COLORADO AVENUE STREET IMPROVEMENTS

COLORADO AVENUE STREET IMPROVEMENTS
VAN BUREN BLVD. TO JACKSON ST.

DESIGNED BY	CS	DRAWN BY	CS	CHECKED BY	EL
REVISIONS	REVISED PER ADDENDUM NO. 1				
MARK		APPR.	DATE

DESIGNED BY	CS	DR	WY	CS	CHECKED BY	EL
APPROVED BY	BY	DATE				
SURVEYOR						
STREET SERVICES						
CONSTRUCTION ADMIN.						
ENGINEERING MANAGER						
REVISIONS	REVISED PER ADDENDUM NO. 1					
MARK	EL 11/3/09					
APPR	DATE

TYPICAL WALL DRAINAGE DETAIL (H=2'-0" TO 4'-0")

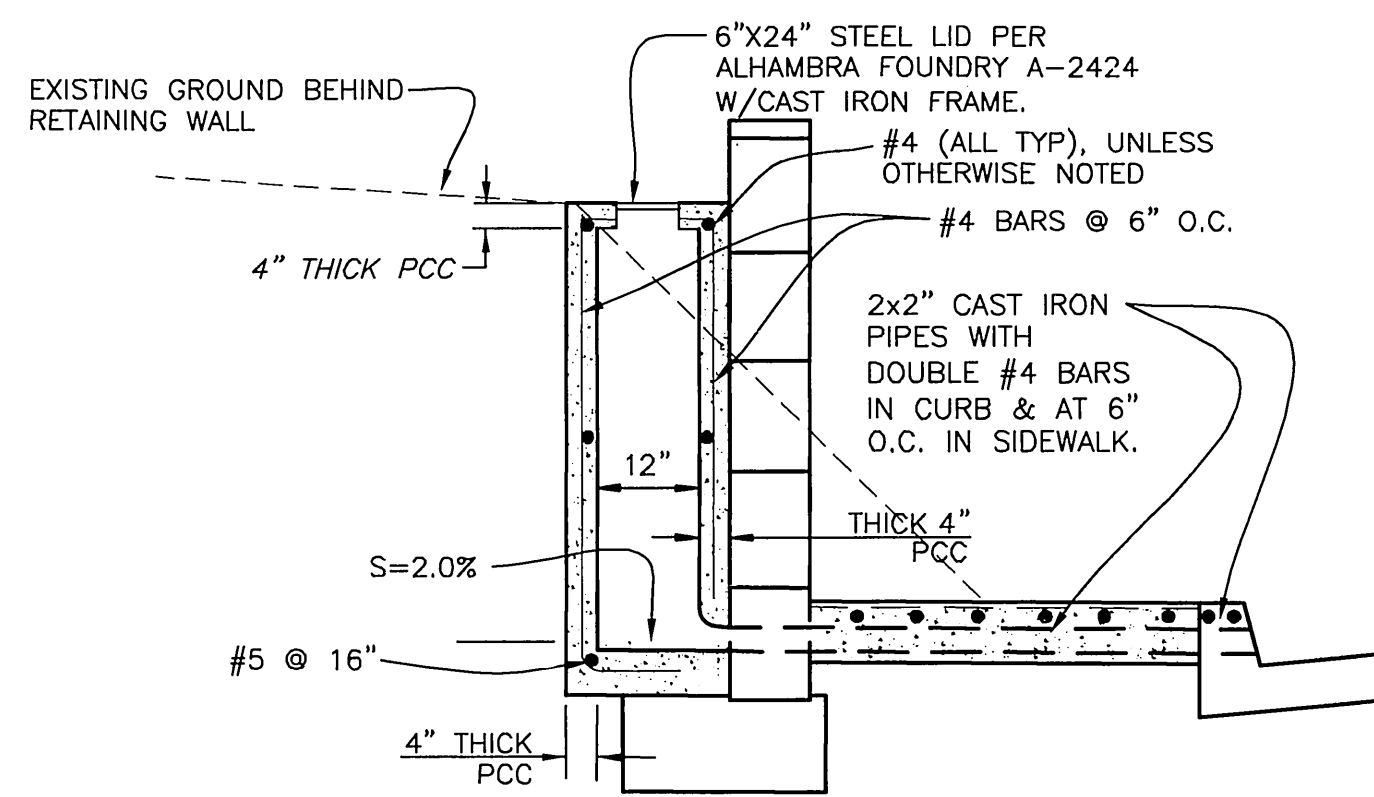
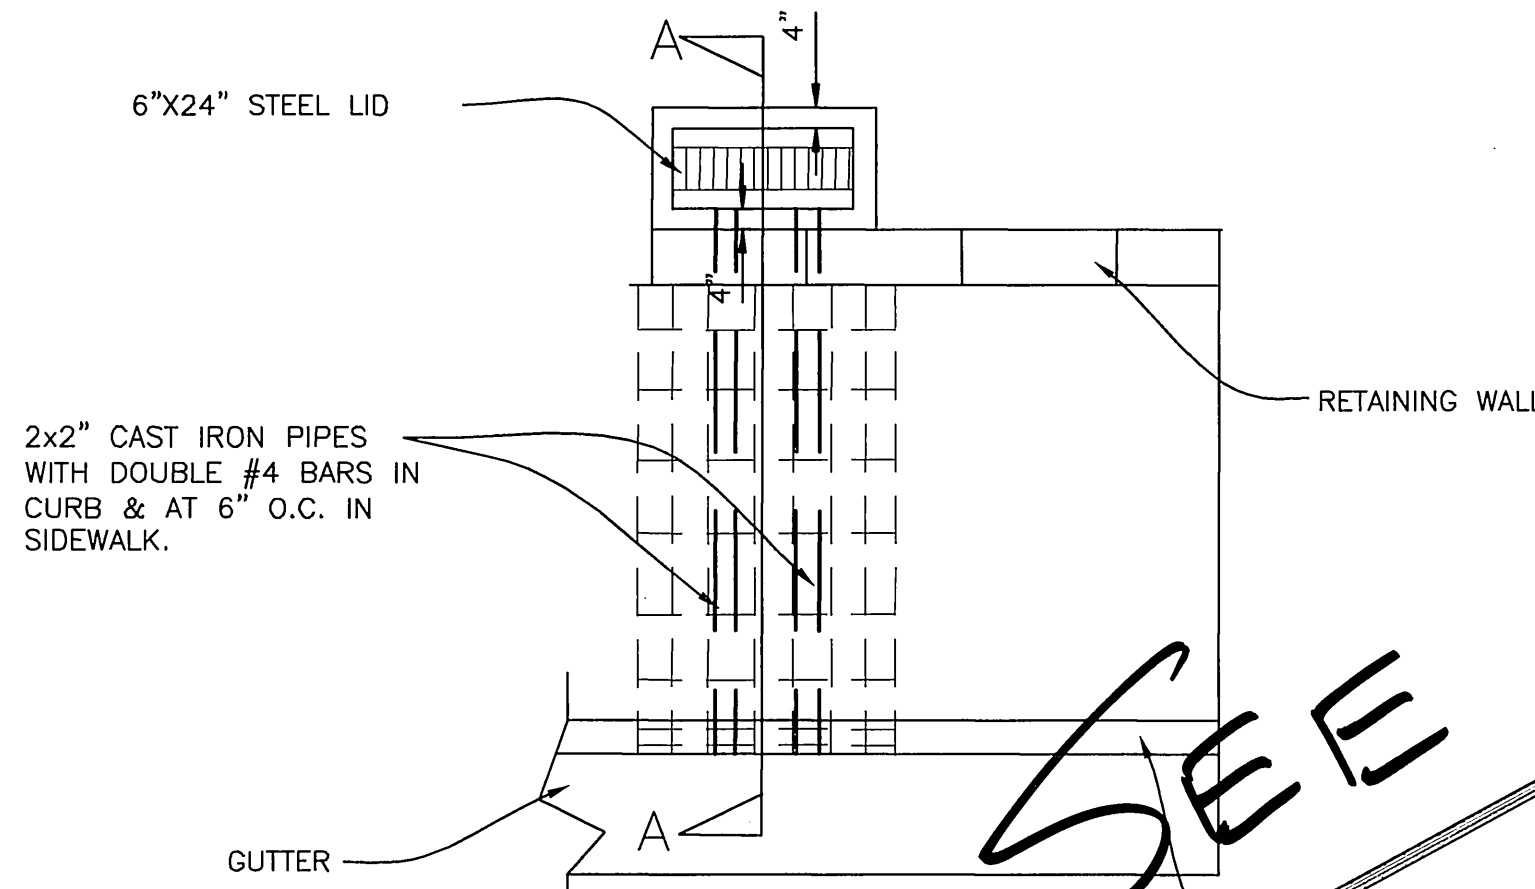
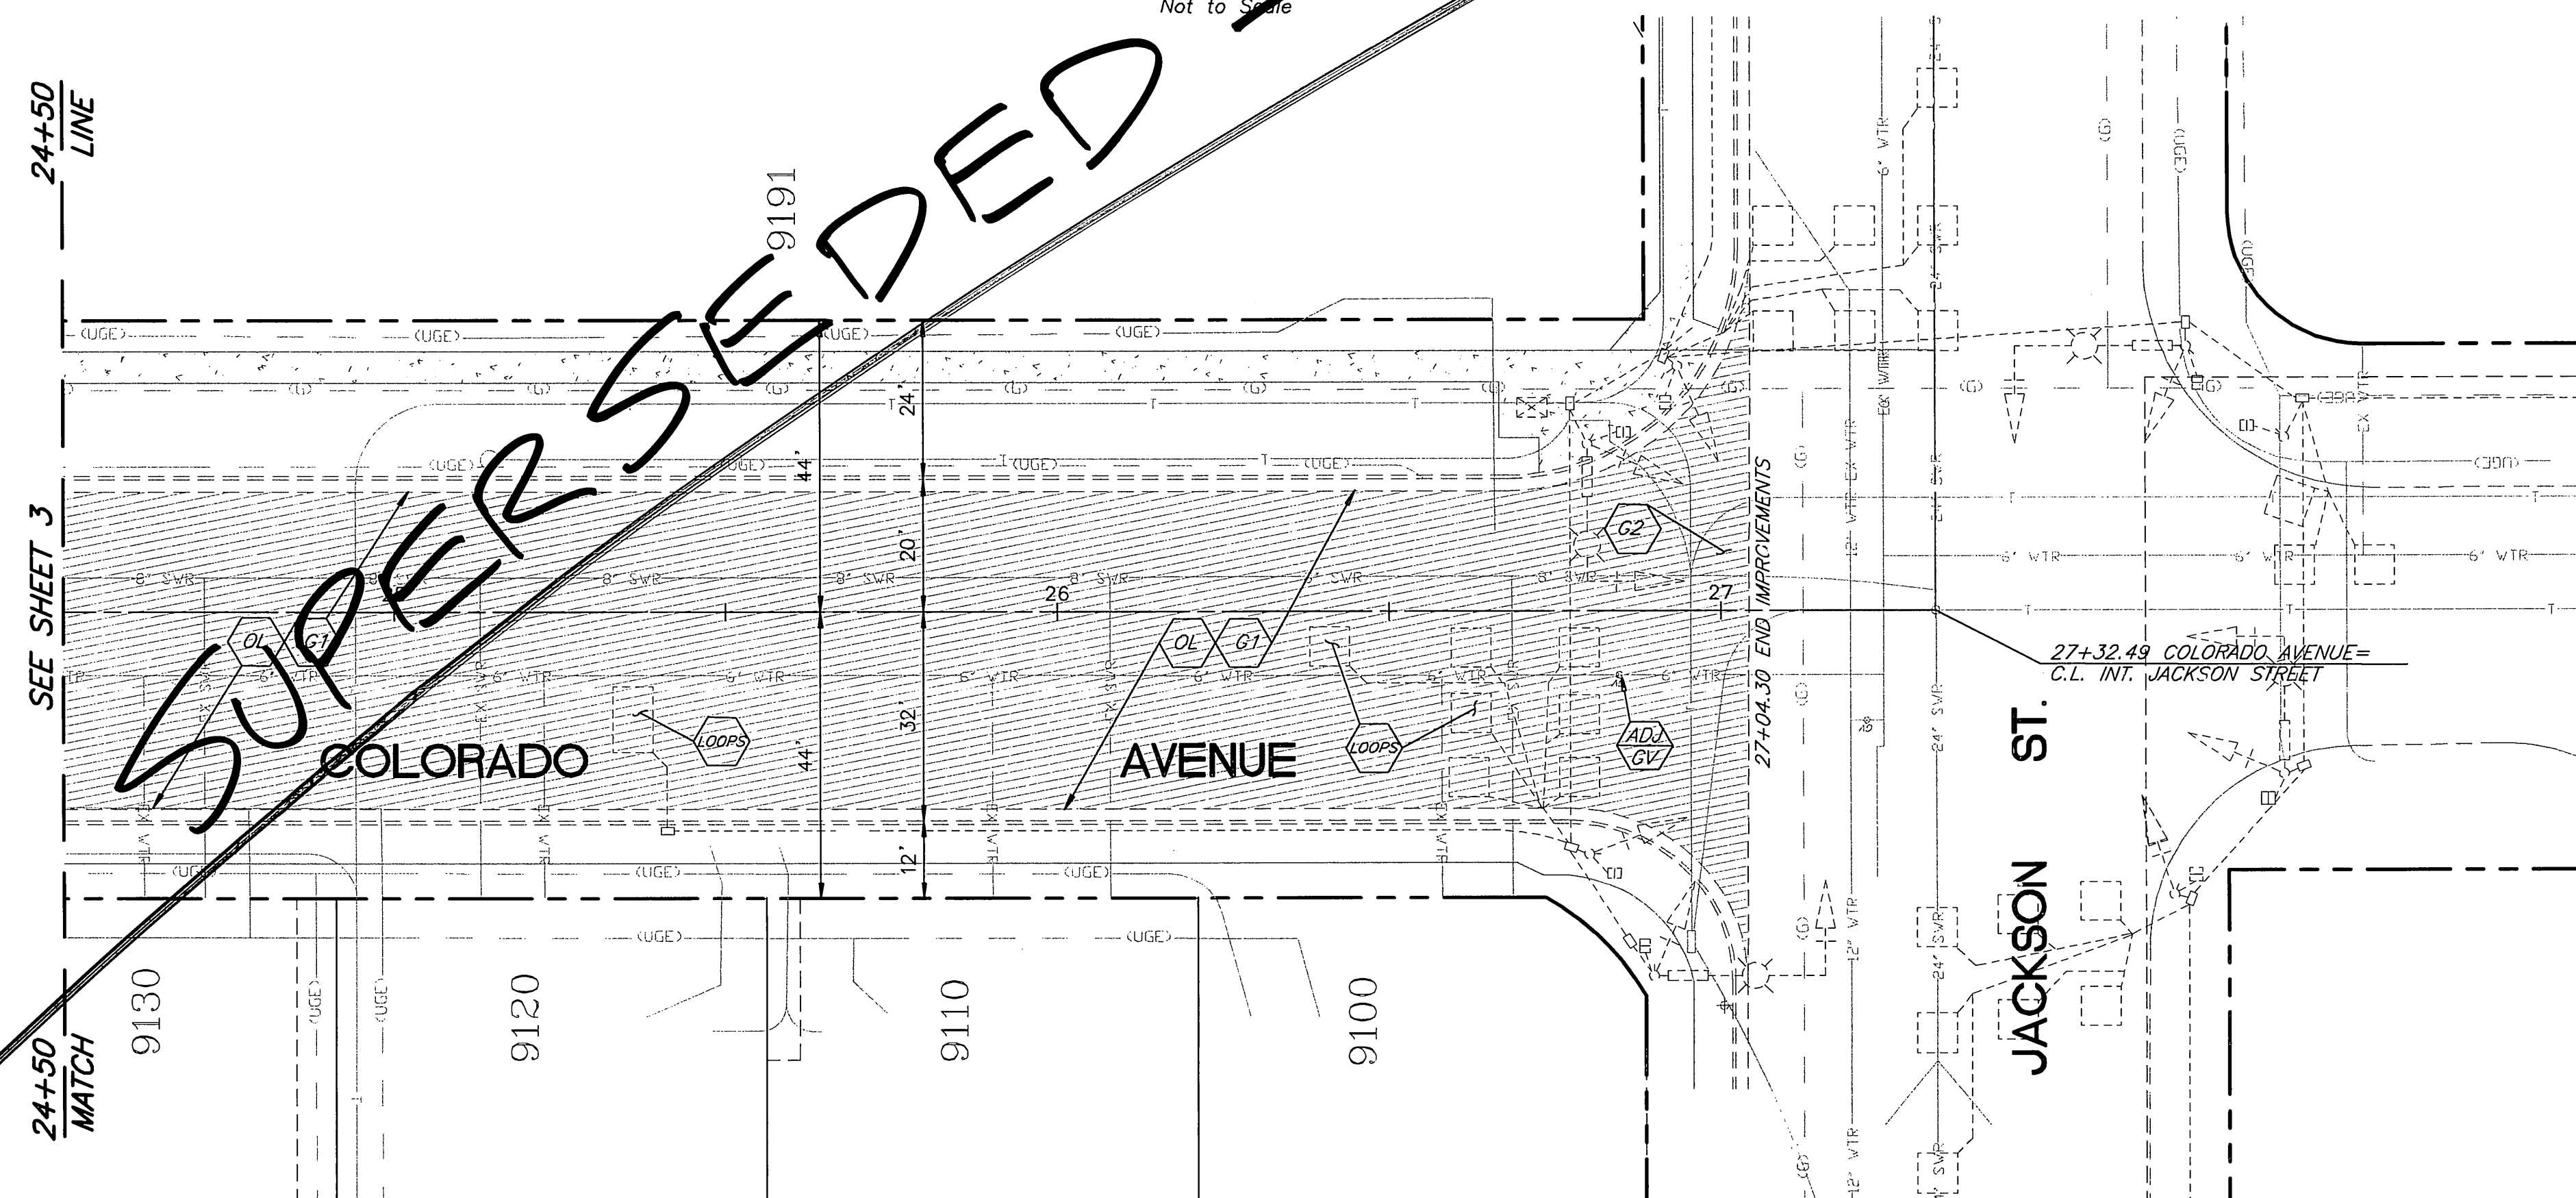
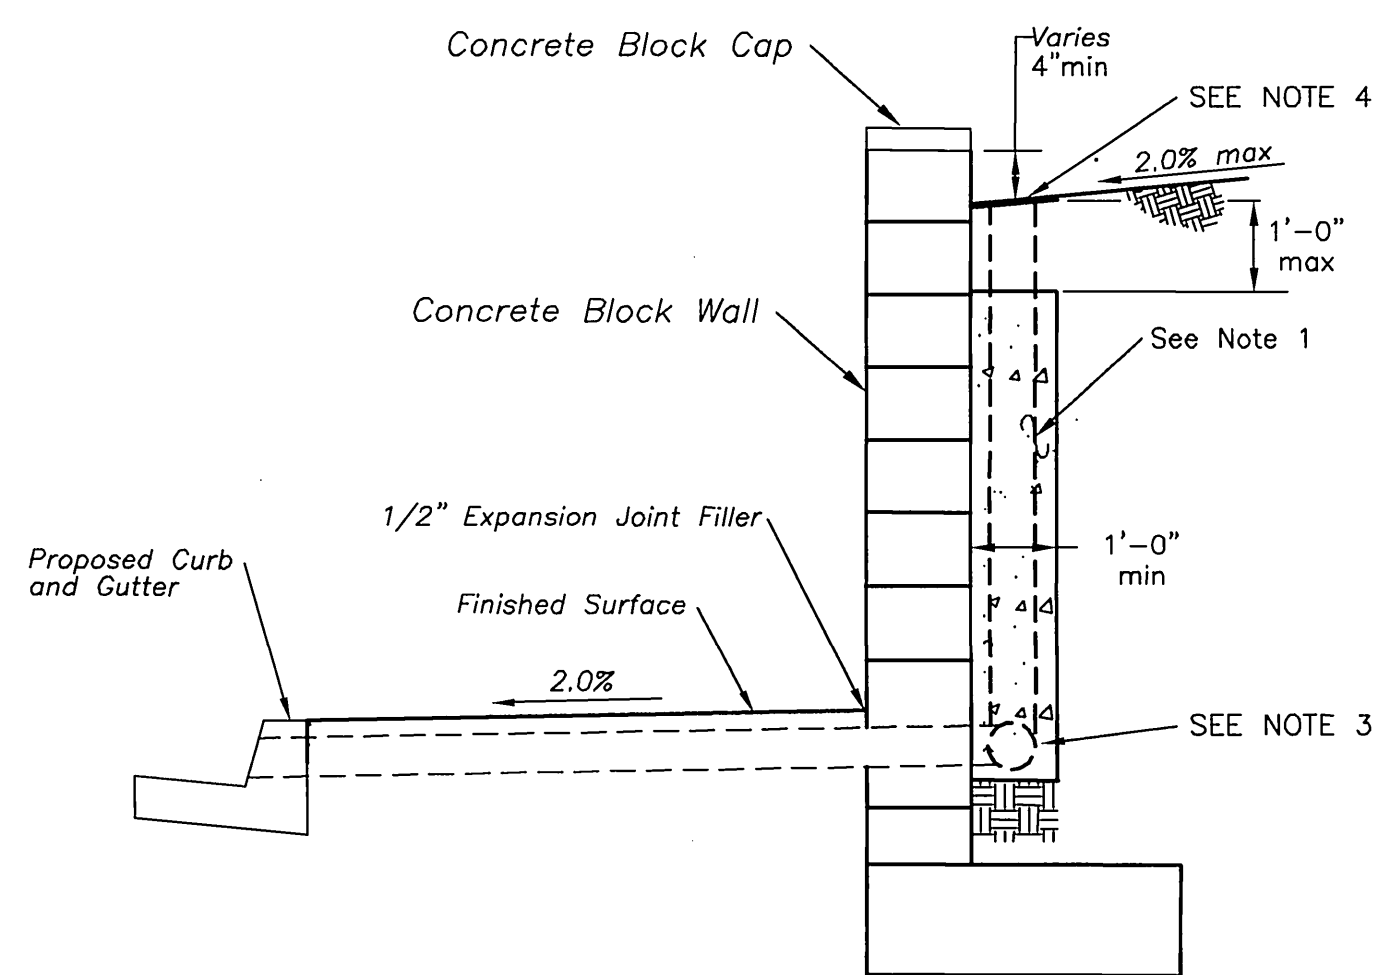
SUPERSEDED
